E C O L O G I C A L R E V I E W

Goose Point/Point Platte Marsh Creation
CWPPRA Priority Project List 13
State No. PO-33

November 8, 2006

This document reflects the project design as of the 95% Design Review meeting, incorporates all comments and recommendations received following the meeting, and is current as of November 22, 2006.

Figure 3. Summary of 20 Year Marsh Fill Settlement (Simoneaux 2006).

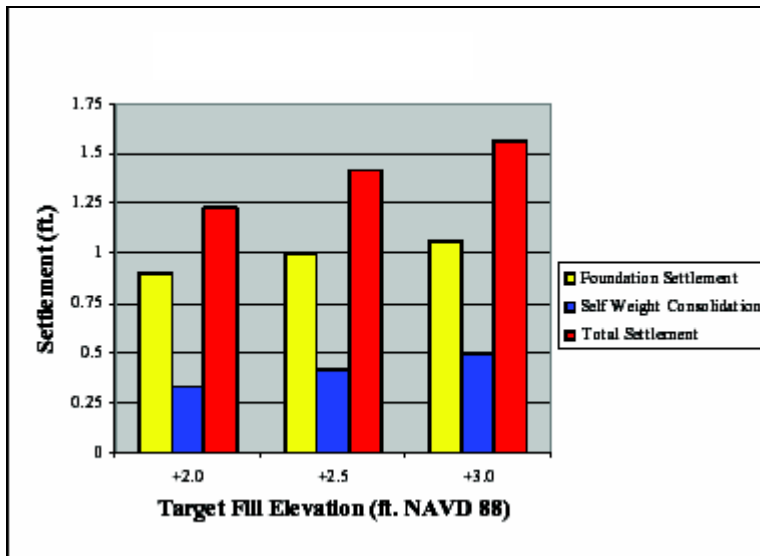
Settlement calculations for the marsh fill were based on two components: (1) foundation settlement (within the deposition area) and (2) self-weight consolidation within the created marsh. Target marsh fill elevations of +2.0 feet NAVD-88 and +3.0 feet NAVD-88 were evaluated in the settlement analysis. The +2.0 feet NAVD-88 fill elevation would settle 1.23 feet to an elevation of +0.77 feet NAVD-88 while the +3.0 feet NAVD-88 fill elevation would settle 1.56 feet to an elevation of 1.44 feet NAVD-88. The analysis showed that most of the settlement of the foundation soils of the marsh fill area would occur within the first year after construction. Figure 3 summarizes the settlement values (foundation, self-weight consolidation, and total) for the various proposed fill elevations (Simoneaux 2006).

Figure 4. Self-weight settlement if a +2.0 feet NAVD-88 fill elevation is constructed (STE, Inc. 2006).

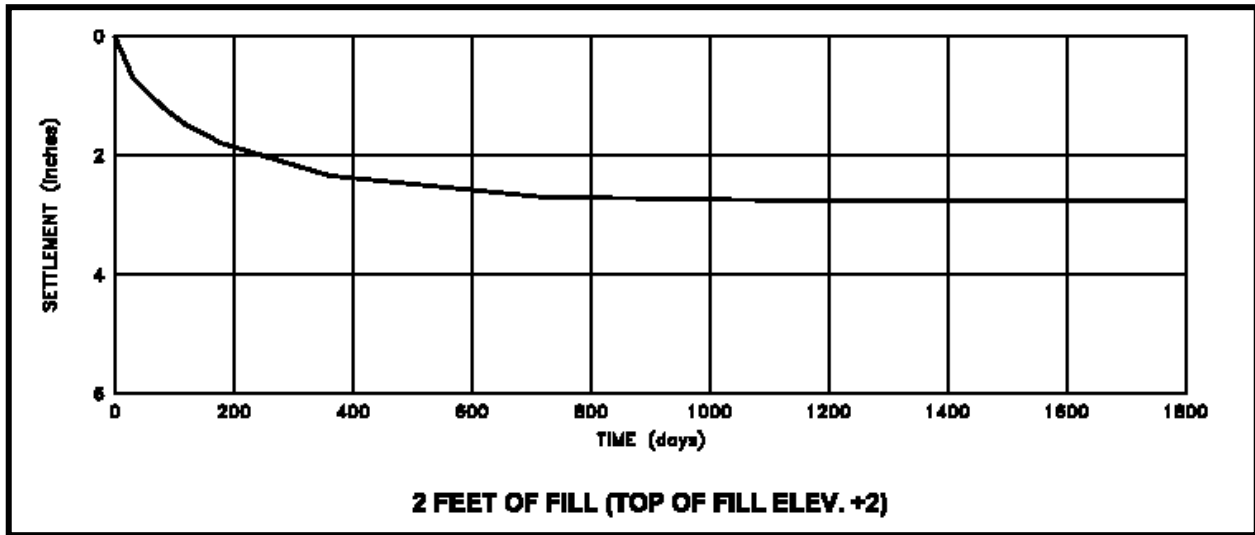
In order to estimate how much settlement will occur within the mass of marsh fill itself due to self-weight consolidation, LDNR tasked STE, Inc. to run additional settlement tests on the borrow area material (Simoneaux 2006). Using a composite sample of borings 1, 2, 8, 9, 10, and 11 taken in Lake Pontchartrain, the time-rate of settlement for this test was calculated for both the +2.0 feet NAVD-88 and +3.0 feet NAVD-88 fill elevations (Simoneaux 2006). The results showed that the self-weight consolidation of the borrow material would be approximately 3 inches for a +2.0 feet NAVD-88 fill elevation and approximately 5 inches for a +3.0 feet NAVD-88 fill elevation (Figures 4 and 5 [STE, Inc. 2006]).

Figure 5. Self-weight settlement if a +3.0 feet NAVD-88 fill elevation is constructed (STE, Inc. 2006).

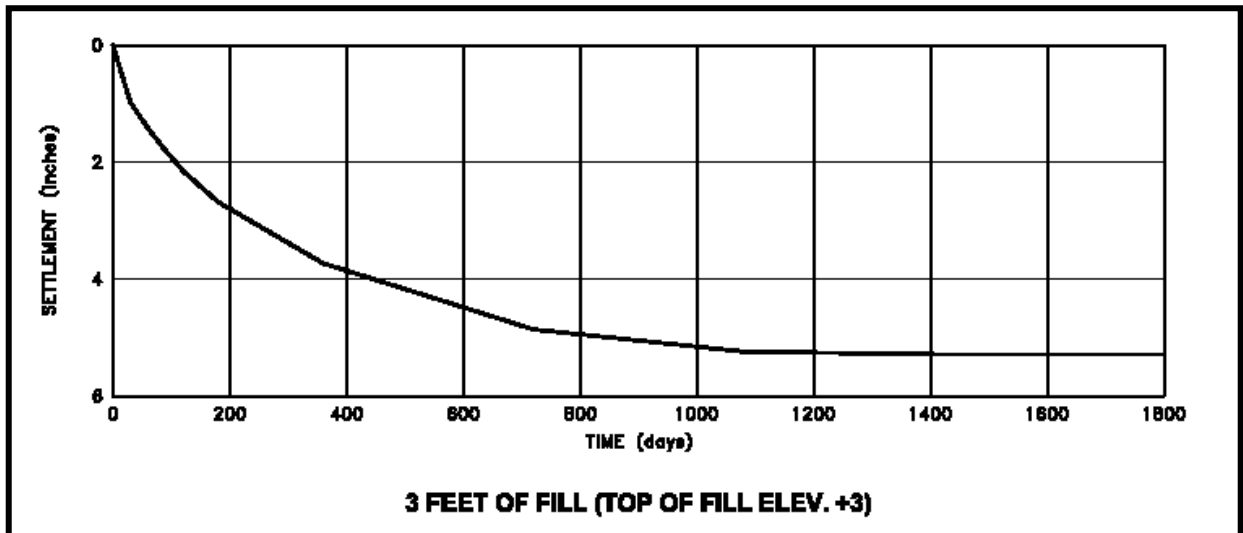
By interpolating between the settlement values for the 2 fill elevations, +2.0 and +3.0 feet NAVD-88, it was estimated that a fill elevation of +2.5 feet NAVD-88 would settle 1.42 feet to an elevation of +1.08 feet NAVD-88 which is close to the existing intertidal marsh elevation (0.96 – 1.0 feet NAVD-88) (C & C Technologies, Inc. 2005). Because the subsidence rates of the project area
